Village of Middleville
T 4 N R 10 W
Barry County
Michigan
Sheet 7

SE 1/4 Section 23
08-41-023-
Scale 1" = 200'

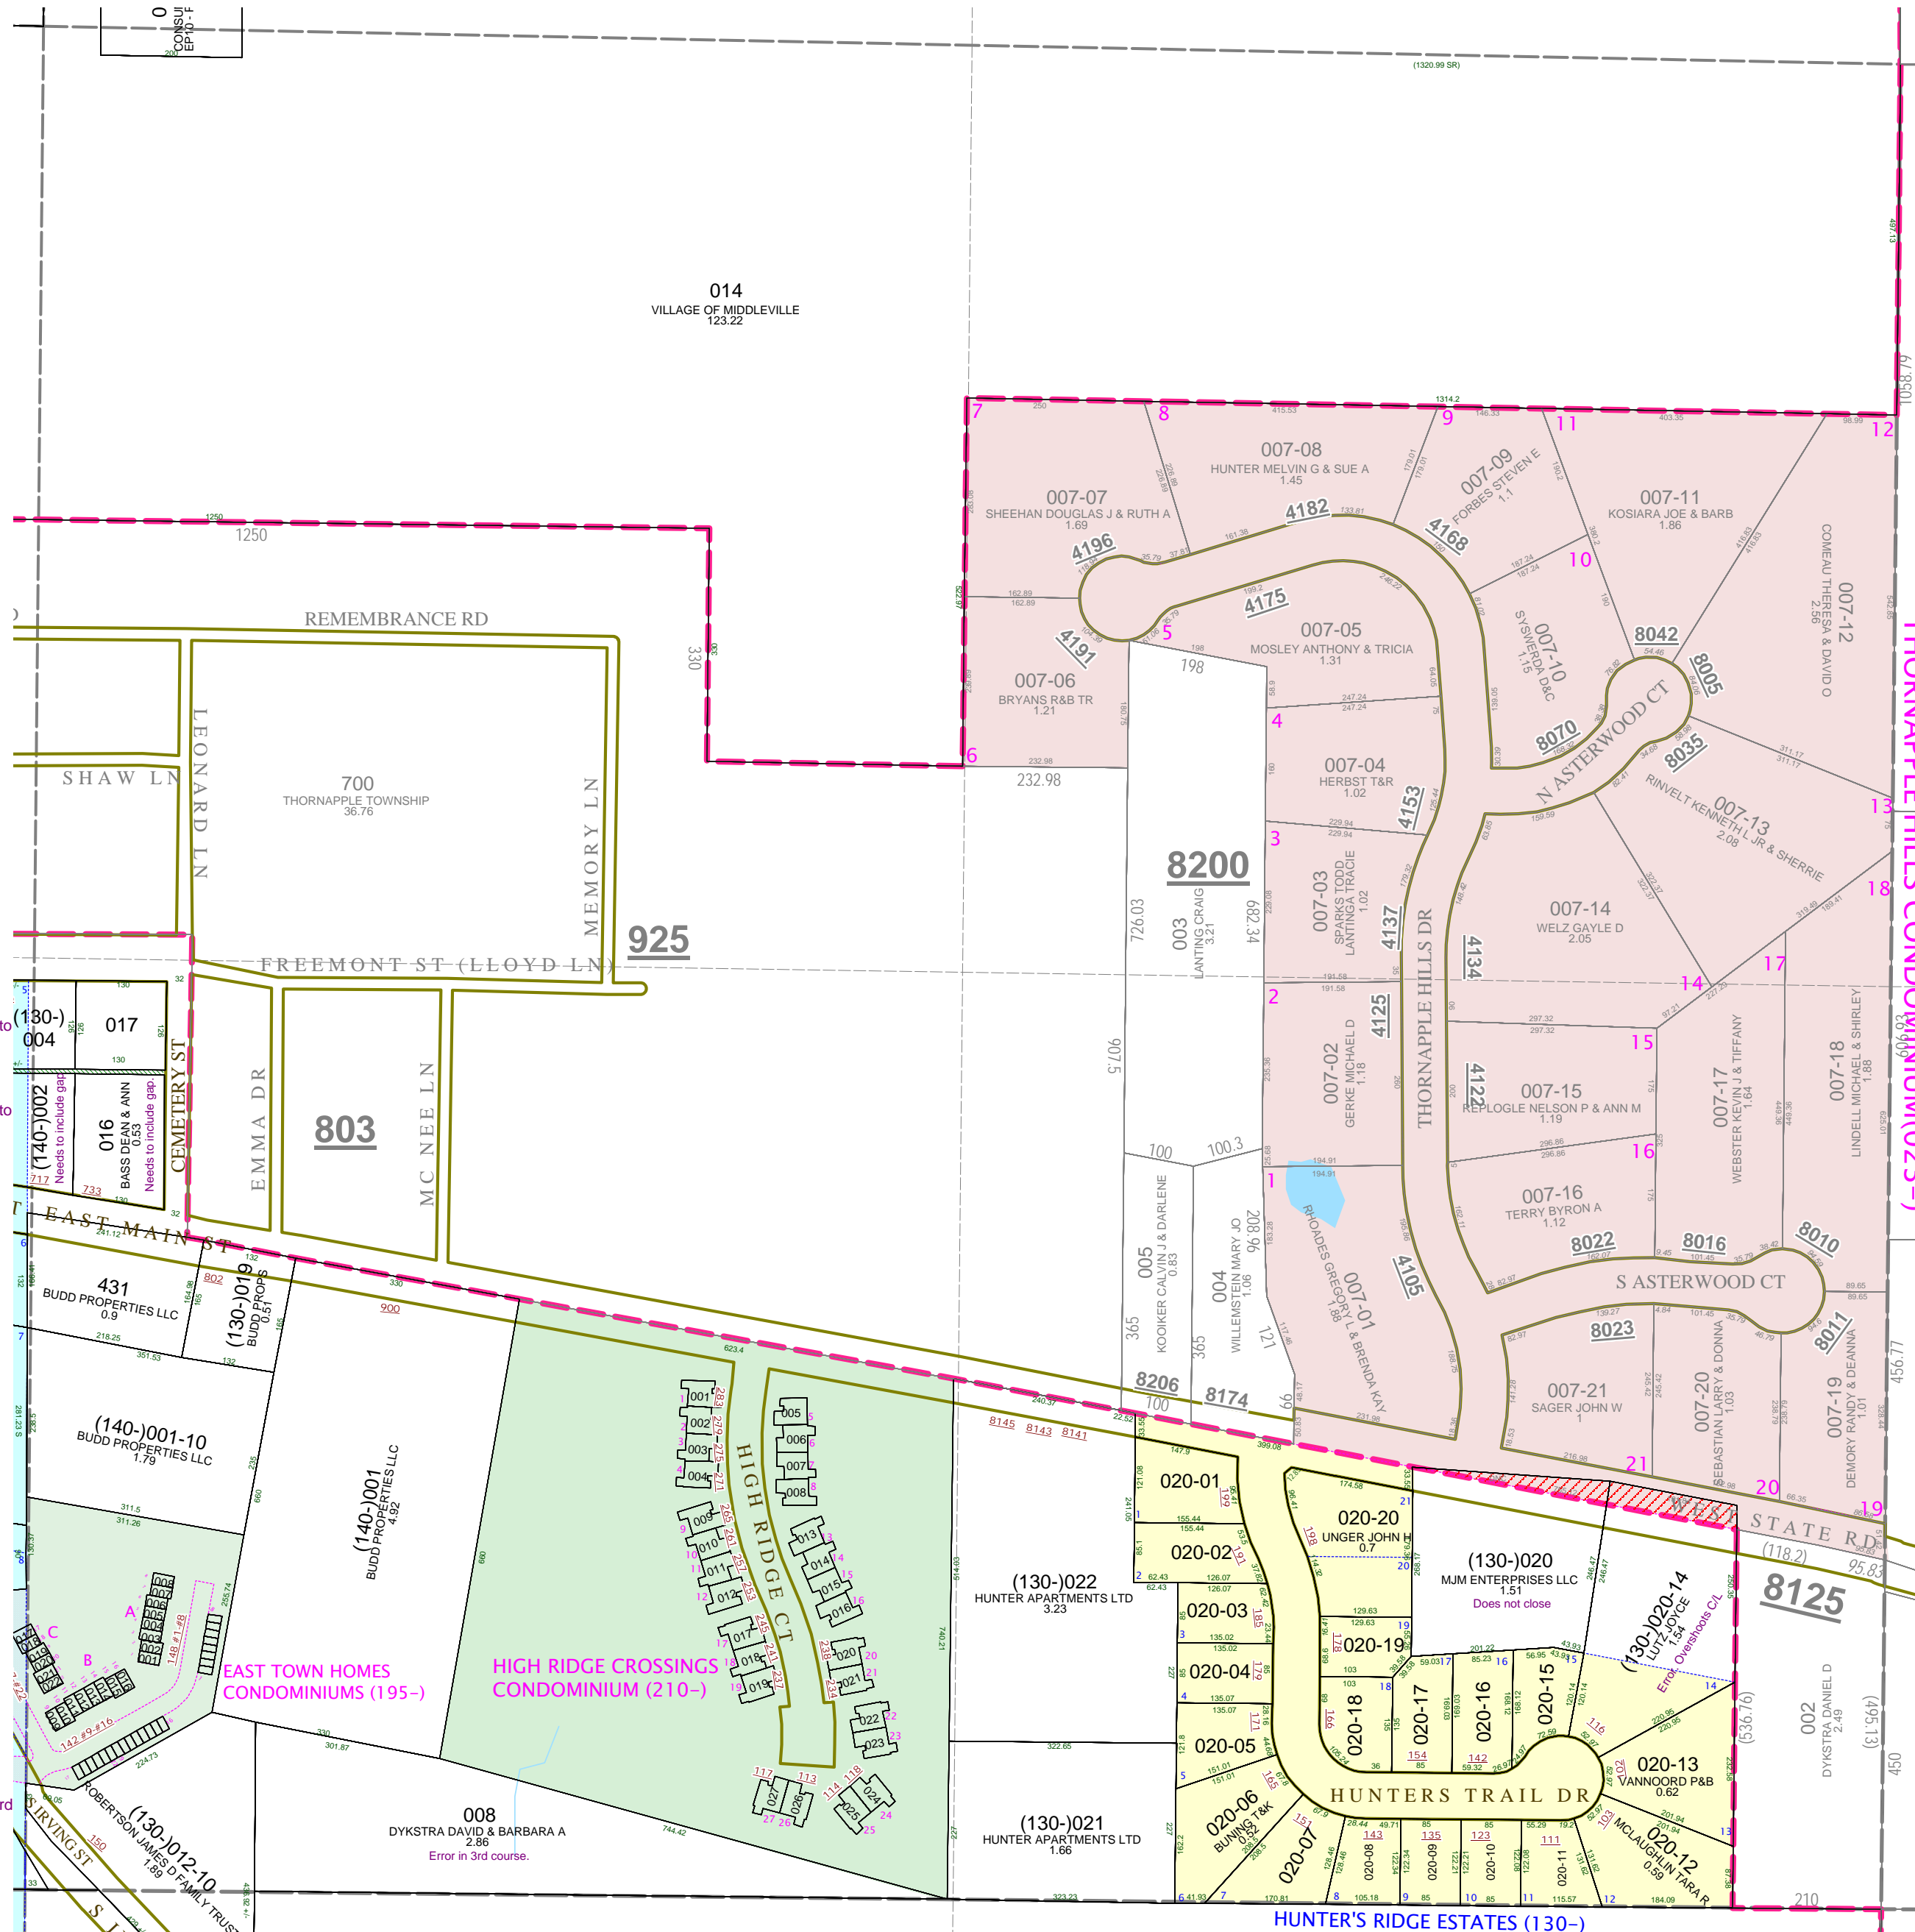
08-41-140-004-00 needs to include gap parcel to its east from L.567-985.

08-41-140-002-00 needs to include gap parcel to its north deduced from Elkins in L.532-65.

08-41-023-016-00 needs to include 6 foot wide gap to its north as deduced in R#1004536.

08-41-023-008-00 has a bearing error in the third course.

08-41-130-020-00 does not close. The road right of way distance on the east line was calculated twice.

08-41-130-020-14 overlaps the condominium to the north. I have a sketch from R#1155866 and in comparing it to Hunter's Ridge Estates and Thornapple Hills Condo, the parcel extends to the north EXACTLY 33 feet past the c/l of the road. Also it was apparently not staked, so it was bad math.
